JOINT REGIONAL PLANNING PANEL
(Sydney East Region)

JRPP No	2014SYE036
DA Number	DA 14/40
Local Government Area	City of Botany Bay
Proposed Development	<p>Integrated Development Application for the construction of a residential flat building at 15-19 Edgehill Avenue Botany, in the following manner:</p> <ul style="list-style-type: none"> • Demolition of all structures on site. • Site excavation and remediation. • Construction of three residential flat buildings as follows: <ul style="list-style-type: none"> • Three (3) storey building containing 9 townhouses. • Four (4) storey building containing 29 units. • Part three (3) and six (6) storey building containing 51 units. • Total of 89 units. • Total floor space ratio of 1.5:1 and a maximum building height of 20 metres. • Two basement parking levels to accommodate 162 vehicles.
Street Address	15-19 Edgehill Avenue, Botany
Lot & DP Nos.	Lot 1 DP 1047383
Applicant	National Project Consultants Pty Ltd

EXECUTIVE SUMMARY

Figure 9 – Distribution of heights (LJB Urban Planning 2014)

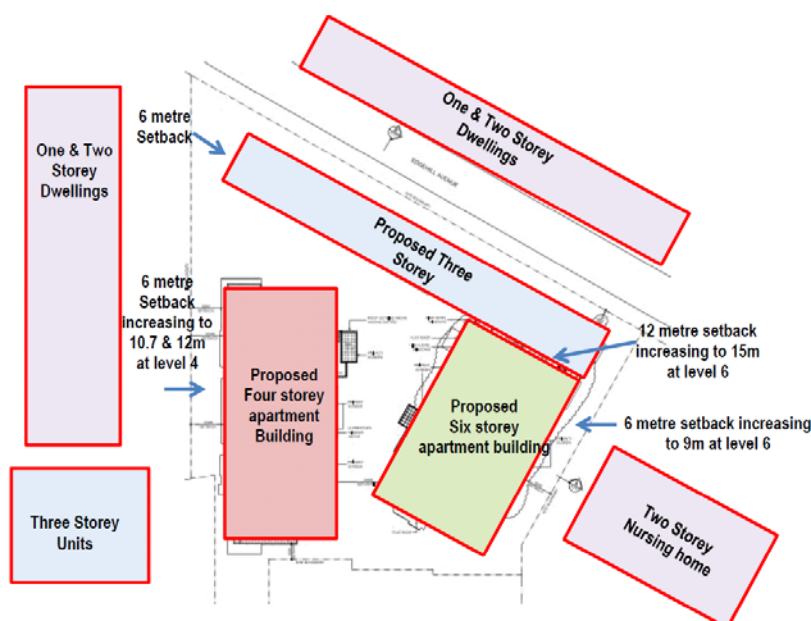
The proposal is substantially lower than the 22 metre height limit provided by the LEP as shown in the table below (i.e. East Block is 18.5m or one storey below the 22m limit not including lift overrun). The 2 to 3 storey townhouses and podium to East Block provide a suitable interface to lower scale development on Edgehill Avenue. In addition East Block has been amended with further upper level setbacks to step away from the street with taller elements of the building positioned behind the podium towards the rear of the site.

West Block is a 4 storey building incorporating Level 4 as a rooftop terrace. As such the building has the presentation of a 3 storey building and provides a satisfactory height transition to 2 storey residential dwellings located to the west of the site. Comparably the 2 to 3 storey townhouses provide an interface with the 2 storey dwelling located opposite the site on Edgehill Avenue.

Figure 12 – Building separation to adjoining nursing home

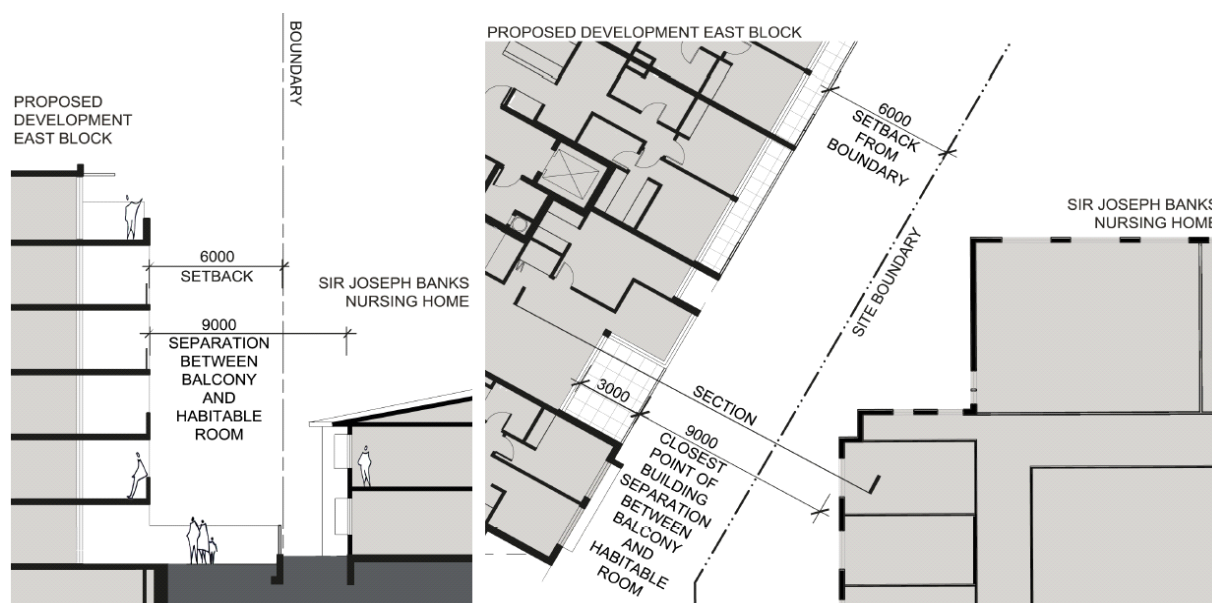
As indicated within the table and Figure 12 above, Unit E208 within East Block (Level 2) have a separation of 9-10m to the adjoining nursing home, which is below the 12m separation requirement.

Figure 13 – Shadow elevations showing impact to No. 25 Chelmsford Avenue

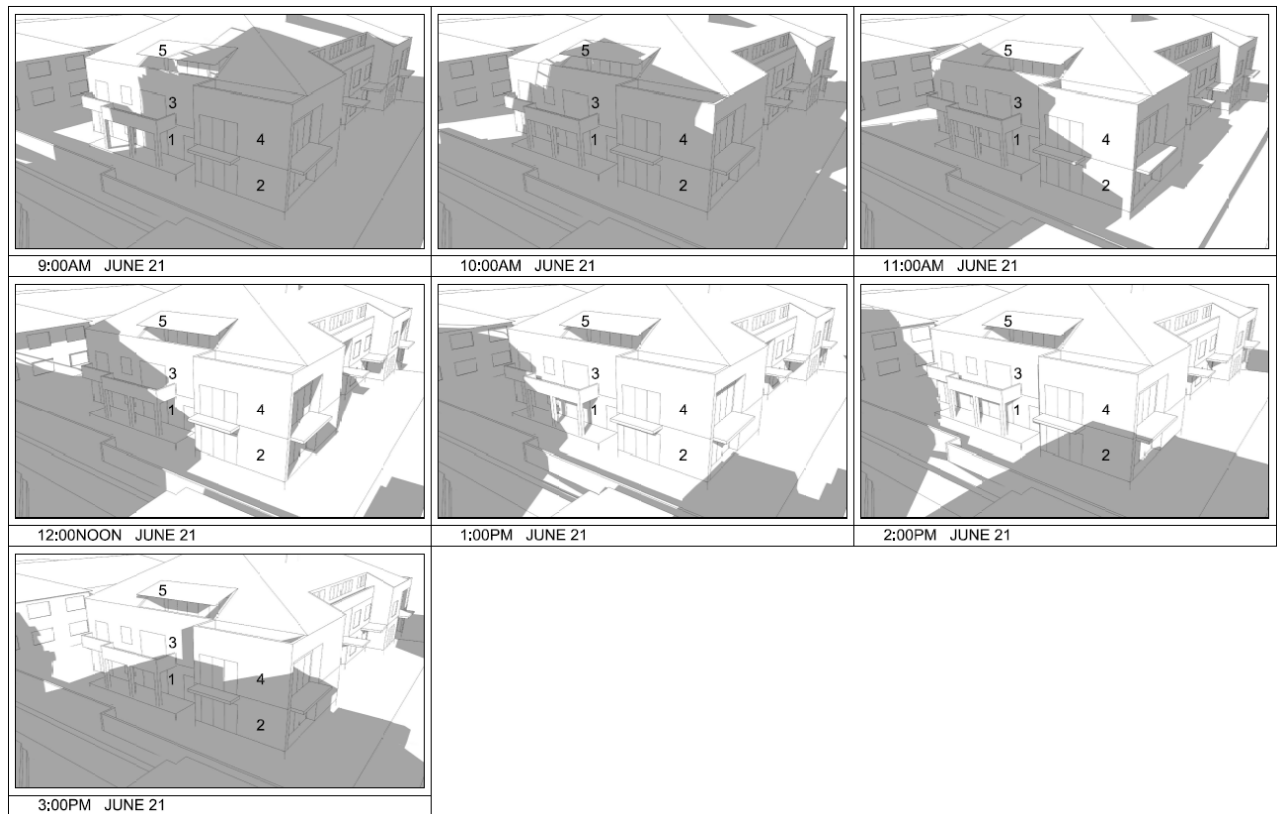
- *Dwellings to the west:-* Private open space to the south west is affected from 9.00-10.00am in the morning, however would receive full sunlight for the remainder of the day. The rear living rooms are not impacted by the shadow created by the development.
- *Residential Flat Building (25 Chelmsford Ave) to the south:-* The majority of the shadow falls to the south and as such, the north facing units belonging to No. 25 Chelmsford Avenue receive the majority of shadow from the proposed development. In response, the

southern portion of the East and West Block were amended to create additional openings to allow more sunlight penetration to the south. As shown in Figure 13 and 14 below, these amendments result in all five of the north facing apartments achieving a minimum of 2 hours sunlight. The private open space belonging to the two ground floor units wrap around the sides of the building and while shadow the northern section of this area is significant, at least 50% of the private courtyards will achieve the minimum requirement.
